Village of Cottage Grove Notice of Public Meeting

RE: Letter of Intent
PUD – GDP
Summit Credit Union Headquarters
Lots 122511, 122801, 124061, 125681
Commerce Business Park
South East Corner of County N and Interstate 94
Cottage Grove WI

RE: **Summit Credit Union Headquarters – Planned Unit Development, Concept**

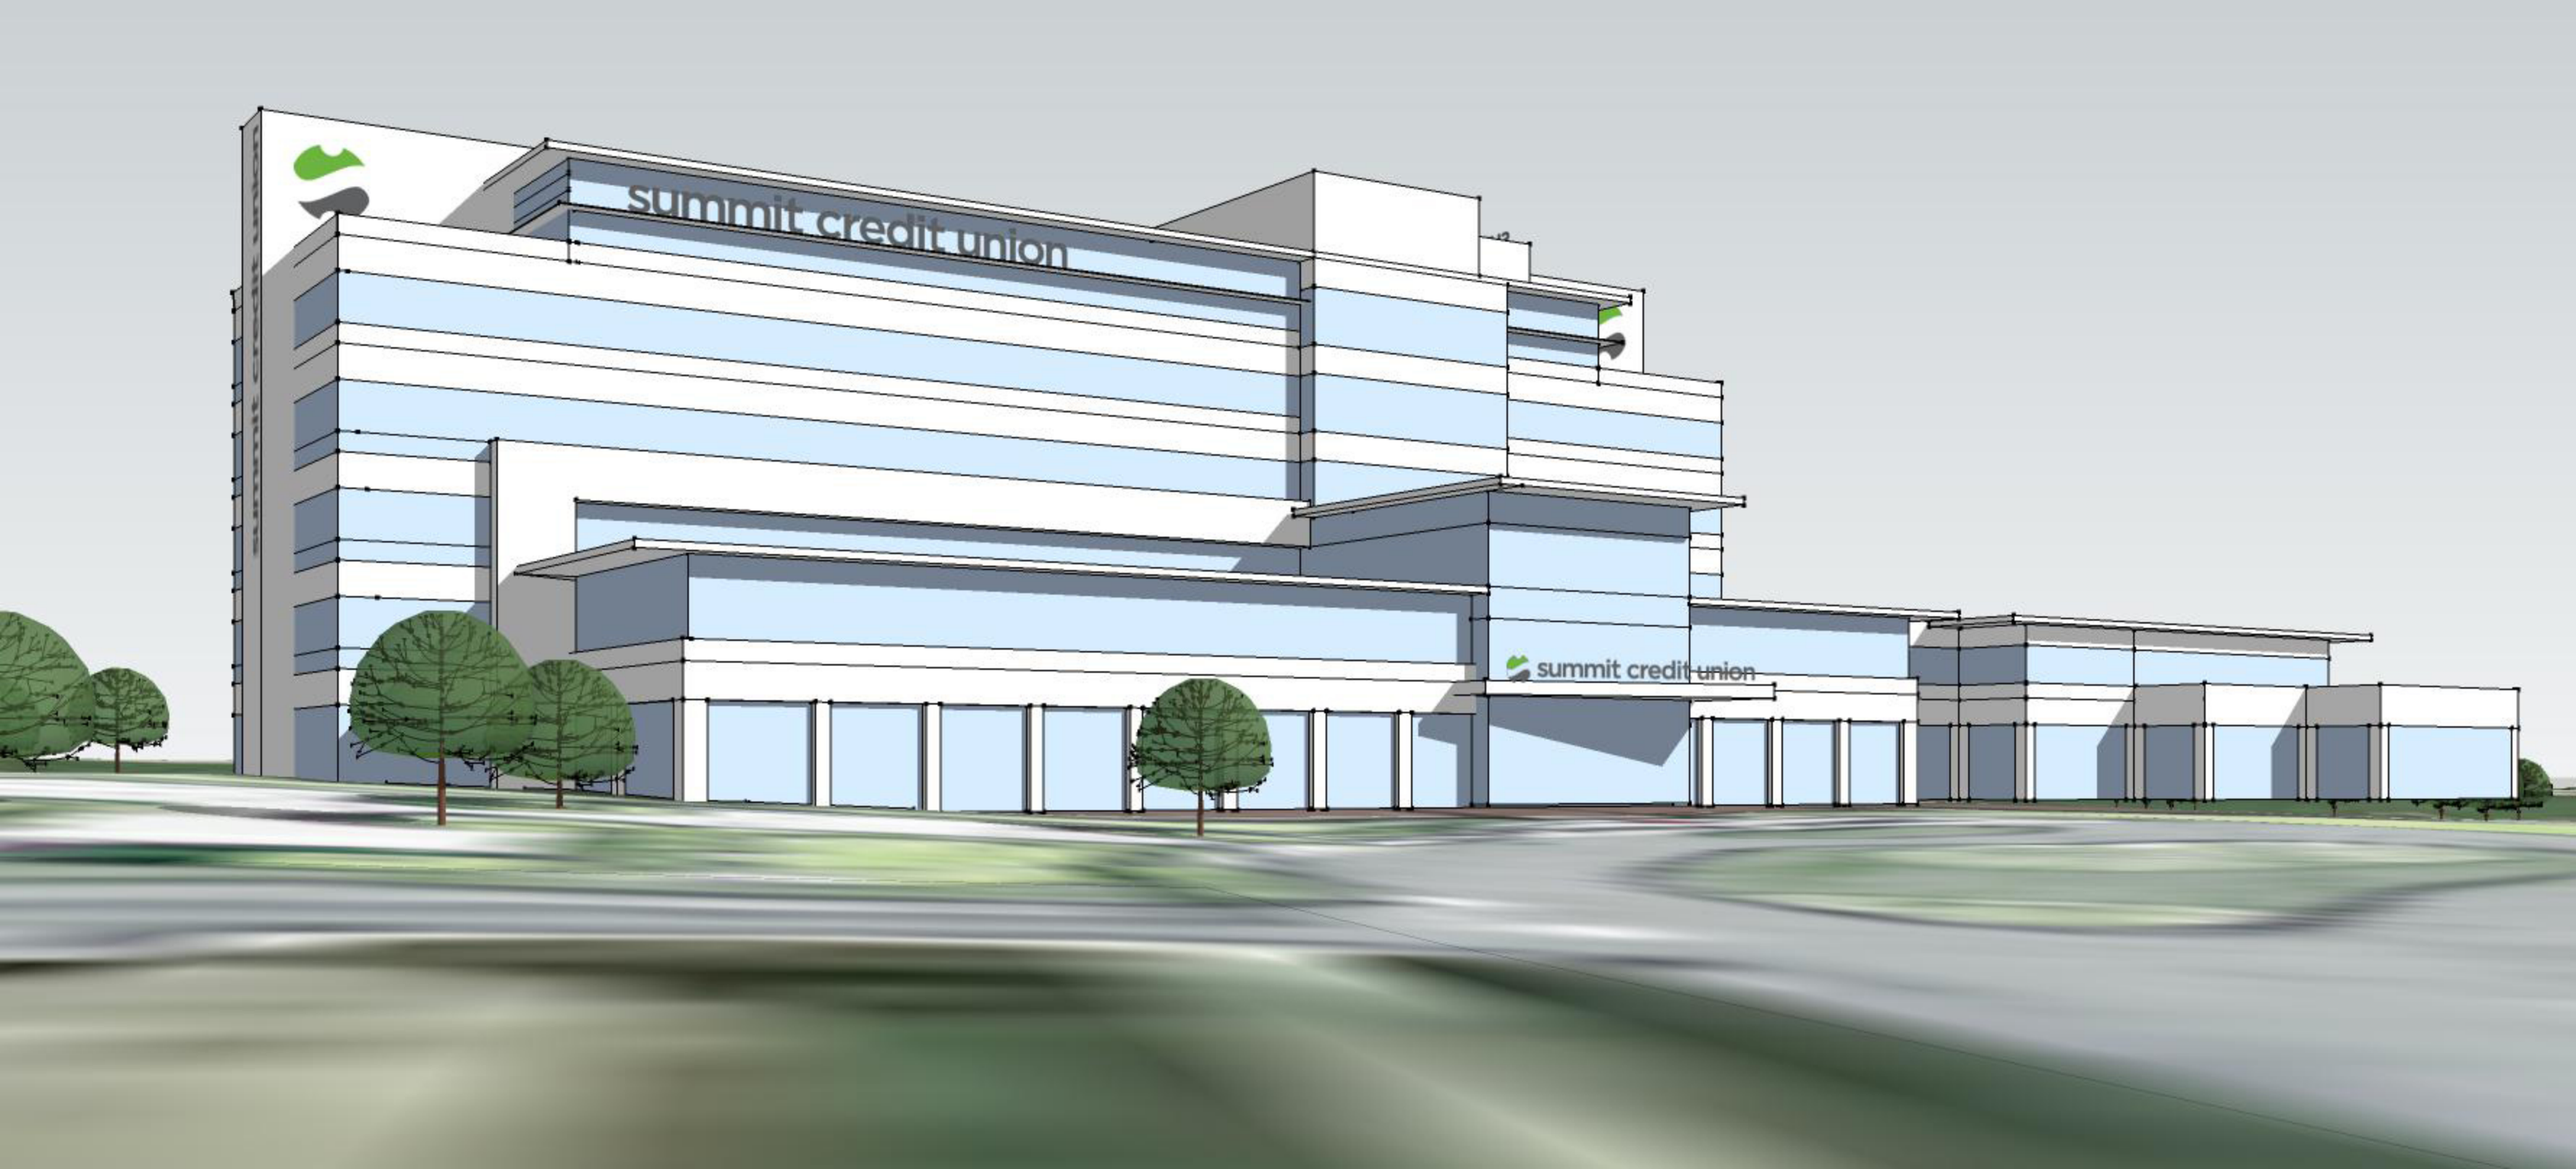
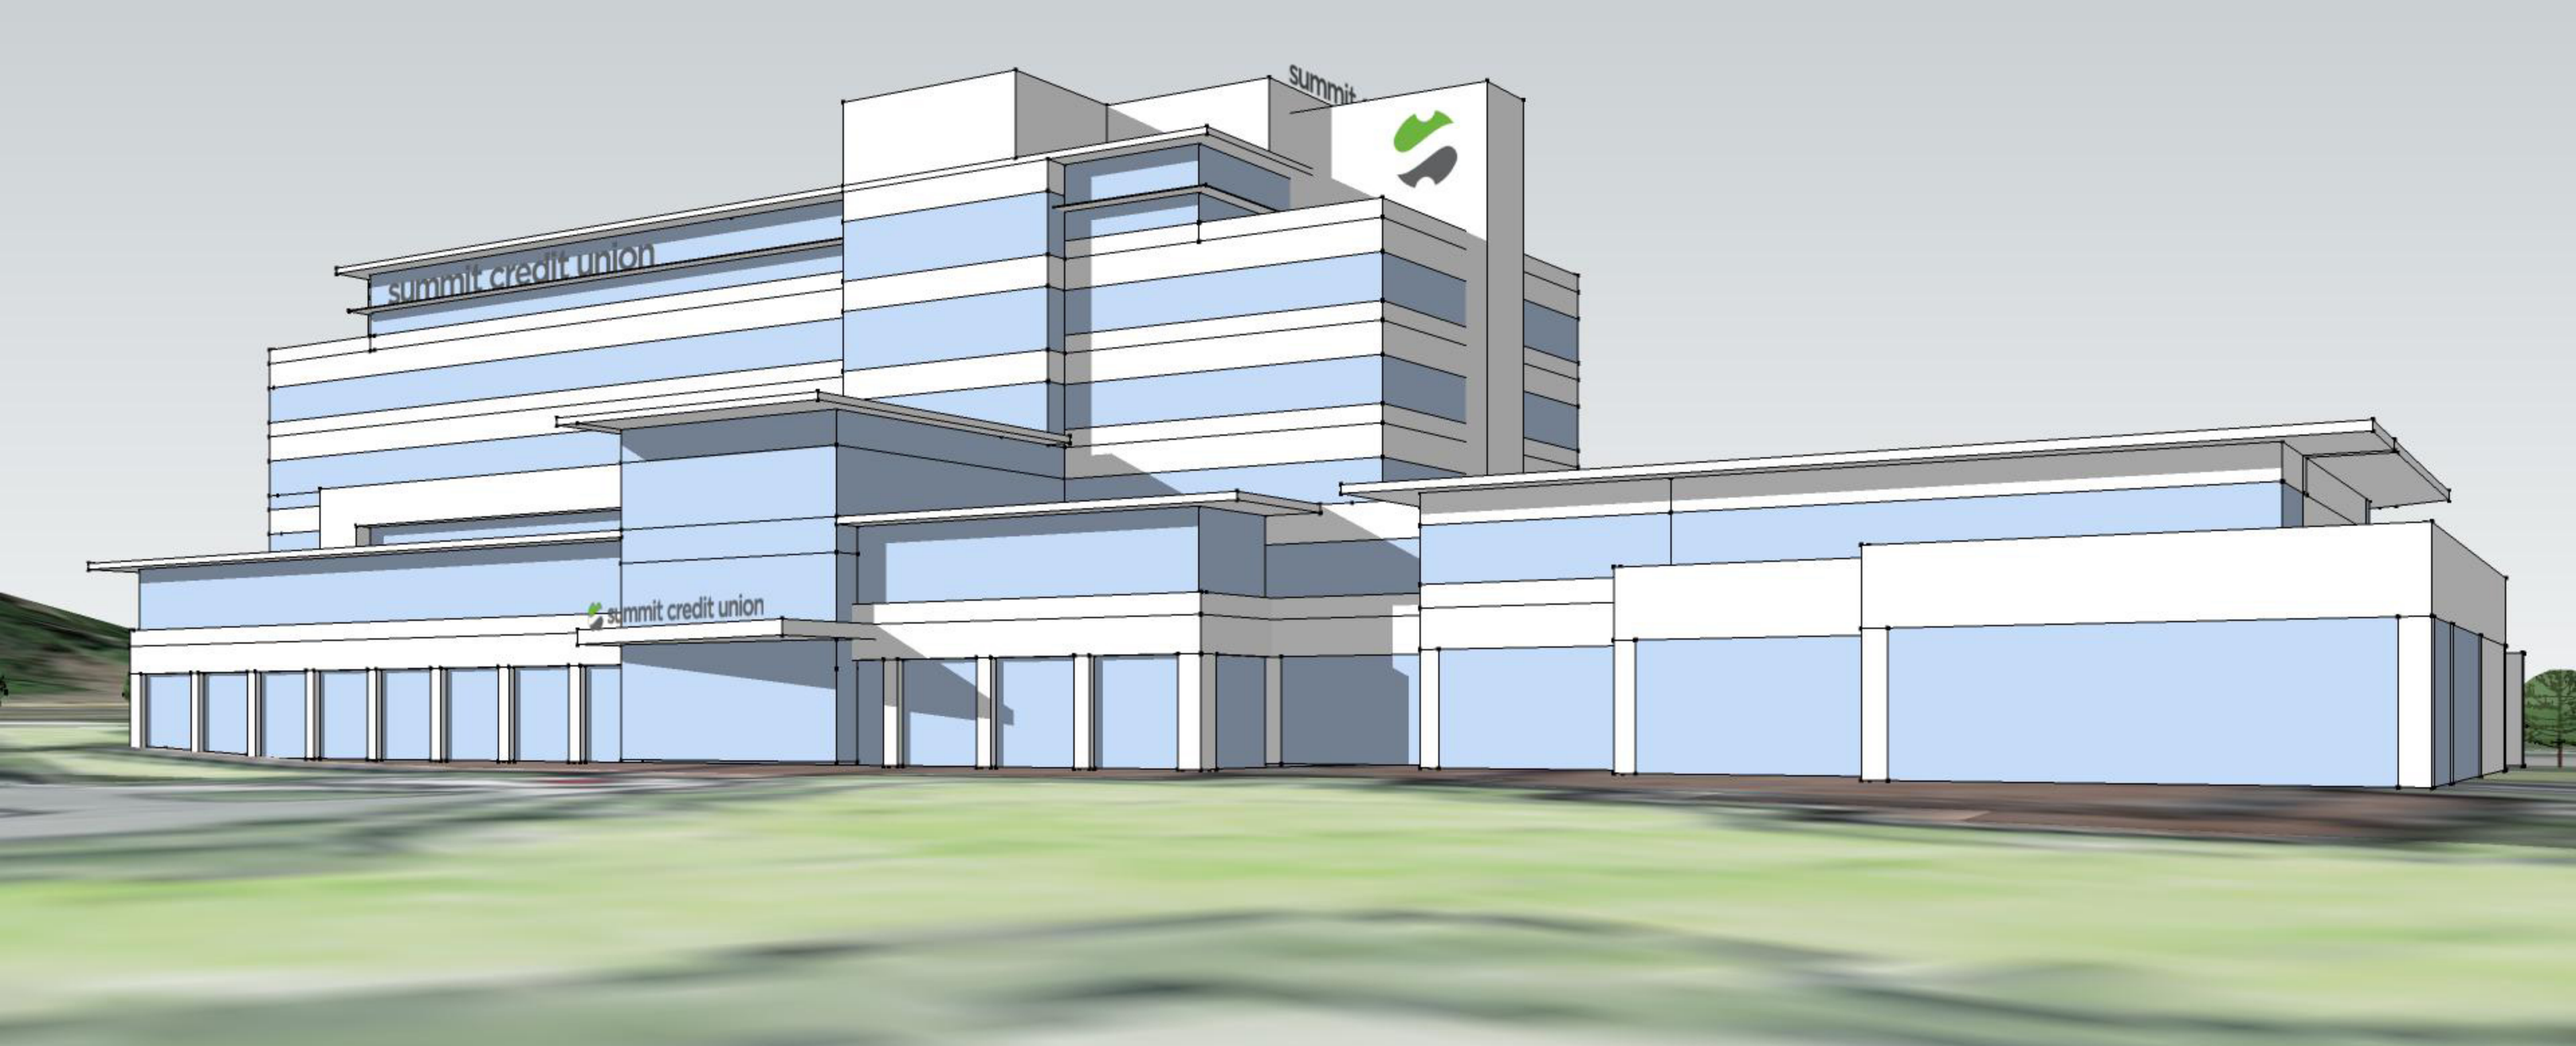
Building Signage

Until final dimensions are determined for the building and the proposed signage, it is not clear if the proposal exceeds size limitations imposed by the Village's Sign Ordinance. However, the conceptual signage shown on the building perspectives appears to be appropriately scaled relative to the building. Staff would support signage similar to that shown in the concepts, regardless of whether it exceeds the limits of the ordinance.
